Customer	: CC-DAR01 Dart Aerospace Ltd.	Drawing Name	: REWORK
Job Number	: 39664		
Estimate Number	: 10804		
P.O. Number	:	Part Number	: D3276042
This Issue	: 03/06/2008 S.O. No. :	Drawing Number	: NCR08-053
Prsht Rev.	: NC	Project Number	:
First Issue	: / / Type : SMALL /MED FAB	Drawing Revision	:
Previous Run	: 39663	Material	:
Written By	: 	Due Date	: 10/06/2008 Qty: 1 Um: Each
Checked & Approved By	:		
Comment	:

Comment: SMALL & MEDIUM FAB RESOURCE 1
REWORK PER DRWG AND NCR08-053

From: David Shepherd [dshepherd@dartaero.com]
Sent: June 26, 2008 1:08 PM
To: 'Chris Provencal'
Cc: 'Mike Petsche'
Subject: RE: NCR D3276-041

From: Chris Provencal [mailto:cprovencal@dartaero.com]
Sent: Thursday, June 26, 2008 10:33 AM
To: 'David Shepherd'
Cc: 'Mike Petsche'
Subject: NCR D3276-041

DRAWING NO. D3276 SHEET 1 OF 1

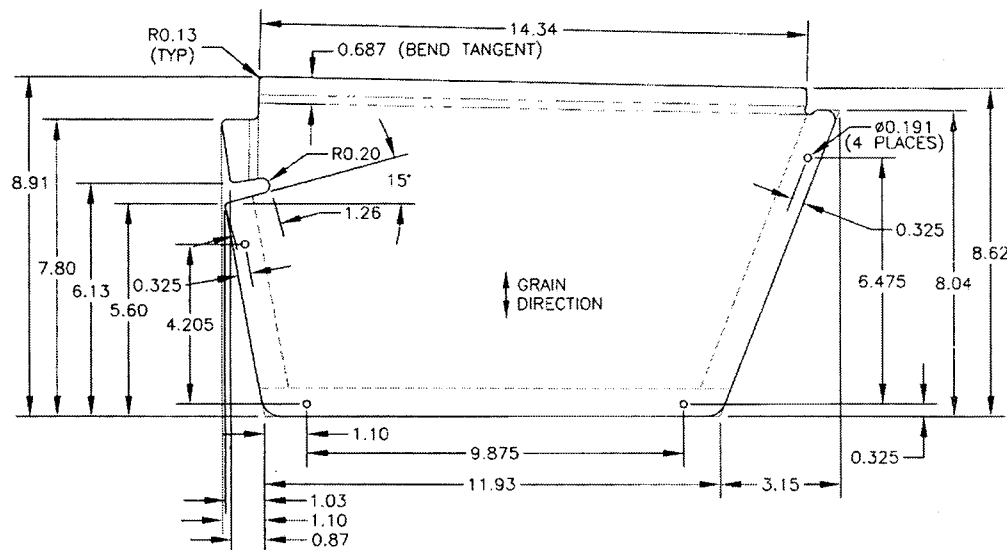
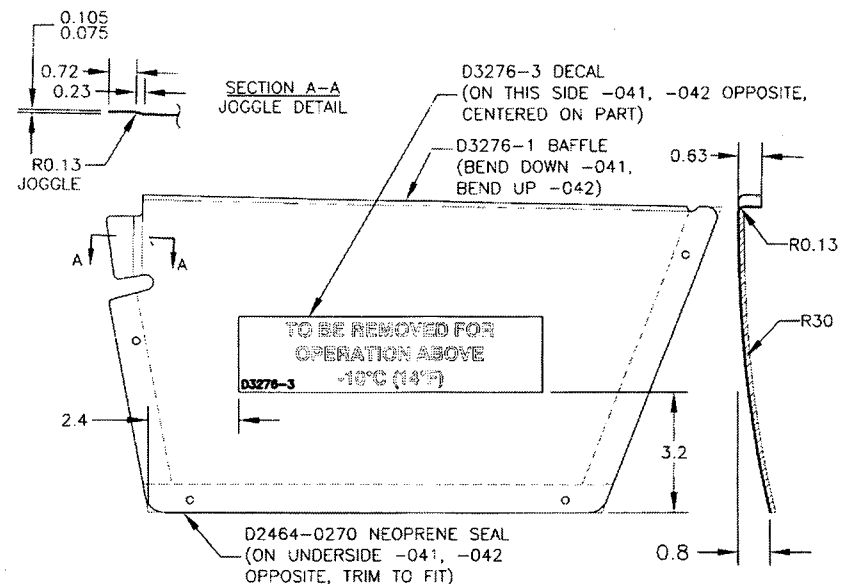
Do we need to clarify the drawing to prevent this from happening again and to change to the 45 degrees for the future? I believe the 45 degrees was covered on a deviation.

Again, though, why is it 22? And why is it only discovered after paint? Its like we need to bend 1 and then check that we are bending it right before we bend the rest.

Qty(22) D3276-041 Baffle Assembly. The joggled tab was bent in the opposite direction from the dwg. They were all reworked to the correct the joggle (re-bent opposite). The grain directions are all at 45 degrees (not vertical per dwg). They were bent while powder coated, so it's impossible to inspect the surface of the aluminum in their current state. One baffle cracked during re-bending.

The part is bolted in, the tab is unlikely to be under any significant stress. However, I'm thinking they should maybe strip the parts (at least locally) to inspect the surface for cracks, especially since one cracked during re-bending. That probably won't be popular....

The re-work is not in an obviously non-structural location so I don't have delegation to approve the parts. What do you think?

I would be inclined to accept these parts. As you mention, they will not be under any load. Also, if the tab breaks off, I have checked with Harvey, and it will fall into an area of the R44 helicopter where it will not cause any damage.

Since they were re-bent after powder, could you do an LPI to check for cracks rather than a powder removal. If the metal is cracked, the paint will also be cracked, right? If not, perhaps you could spot check a couple for cracks?
